THE CITY OF KEY WEST

ADDENDUM # 1

ITB – 13-002

CONSTRUCT KEY WEST CEMETERY MAUSOLEUMS – CE 1003

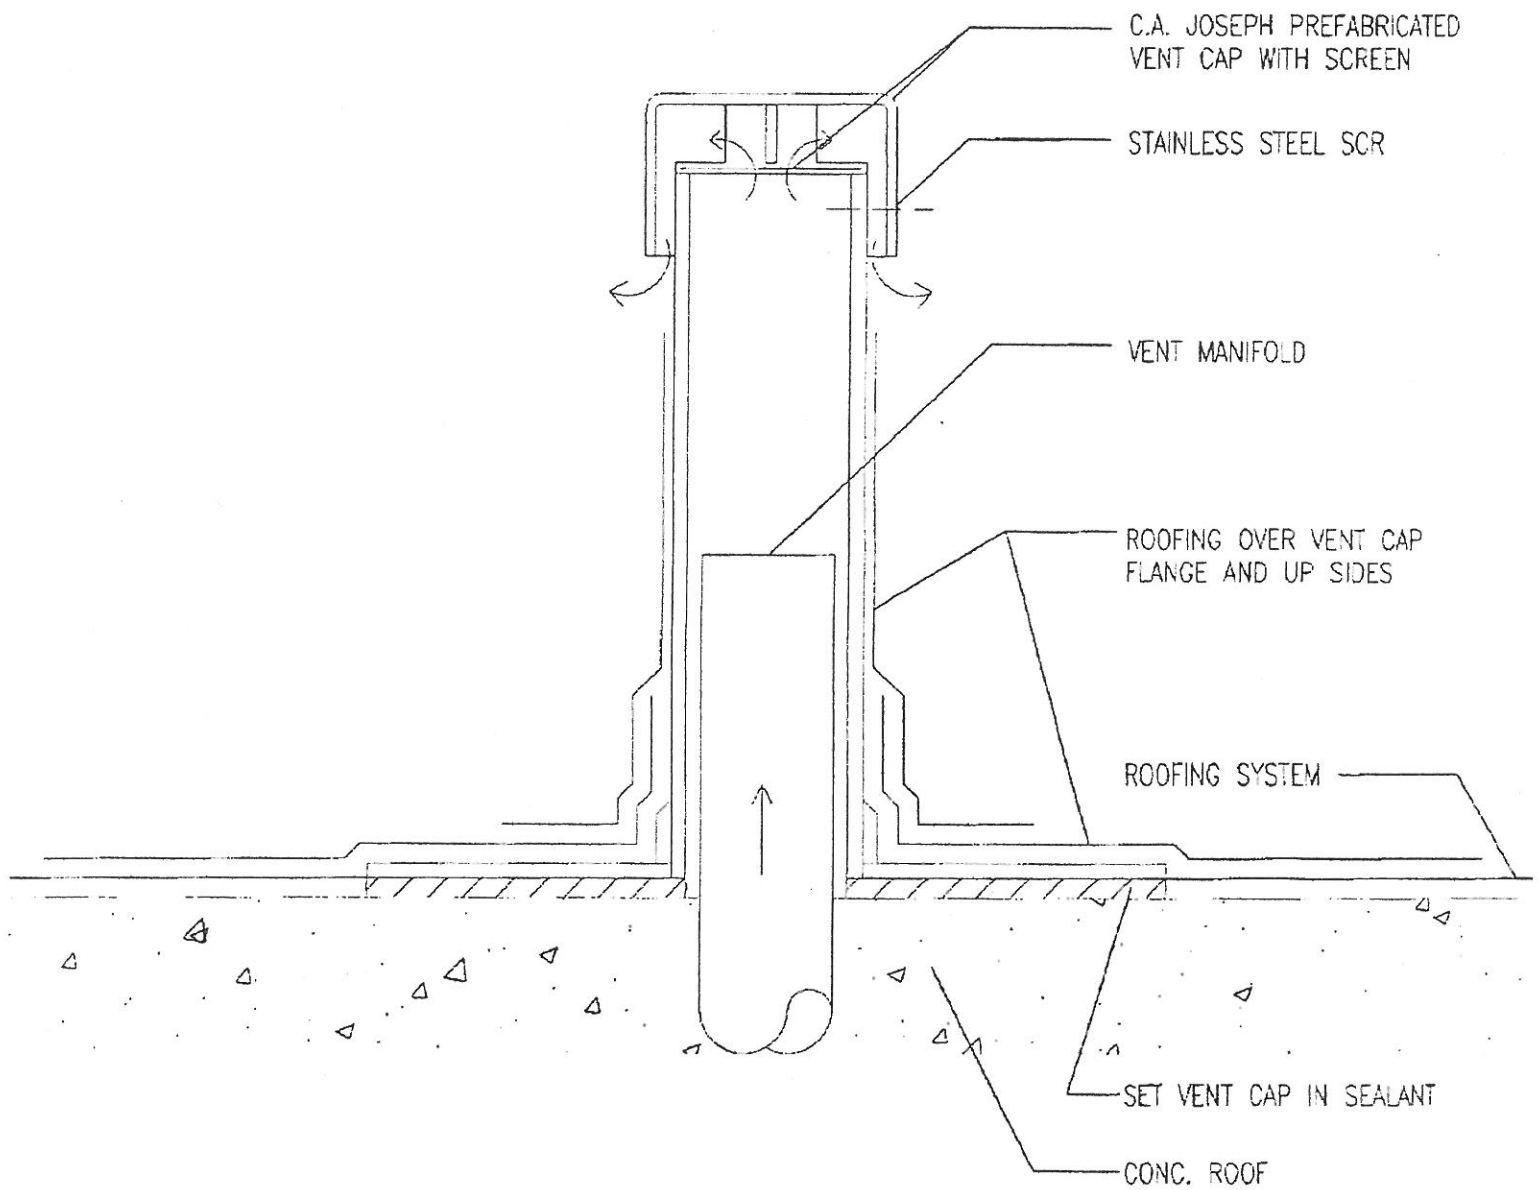
1.) In the Scope of Work on page 66 Part 1 Item 1.1 Contractors Responsibilities please **delete:**

“A 7' -1 0" sidewalk shall be installed along the front of the crypts, and a 10' -0" sidewalk in front of the niches” and **replace with:**

Install a 10 foot long x 5'8" wide sidewalk on the south side of the mausoleums

Install a 61 foot long (the total length of the structure) x 10 foot wide sidewalk

All sidewalks are to be 4" thick 3000 psi concrete with broom finish

CRYPT VENT DETAIL

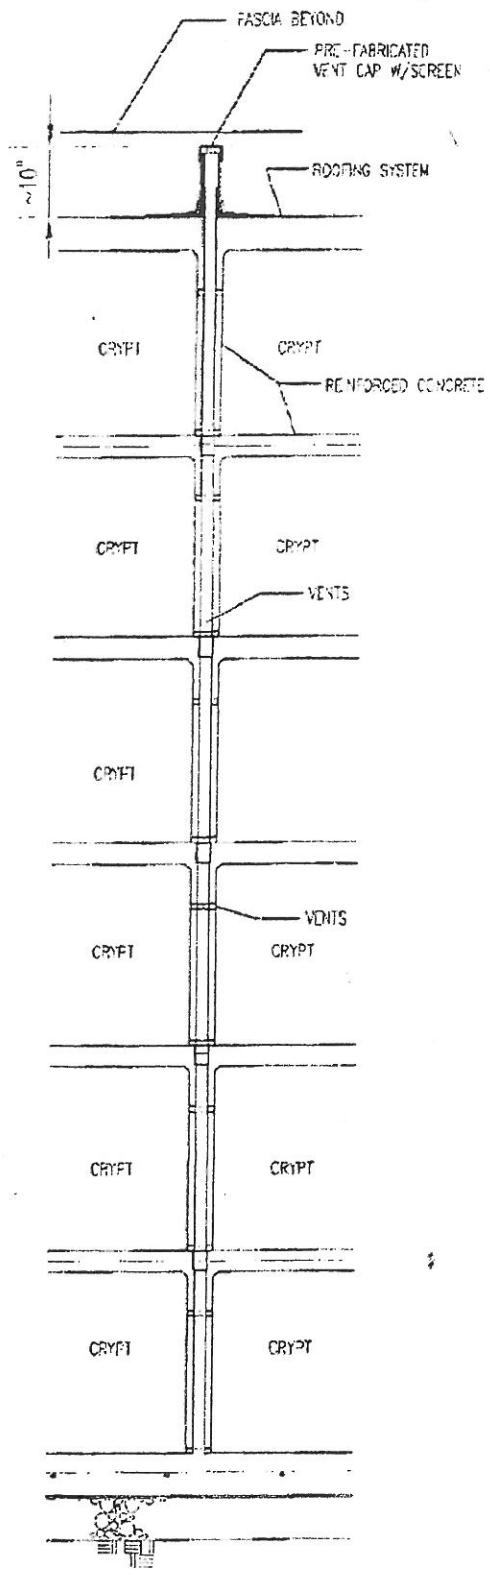
2.) Crypts shall include venting in accordance with the 2010 Florida Building Code

Please see two (2) attachments of Schematic Venting Diagrams for informational purposes:
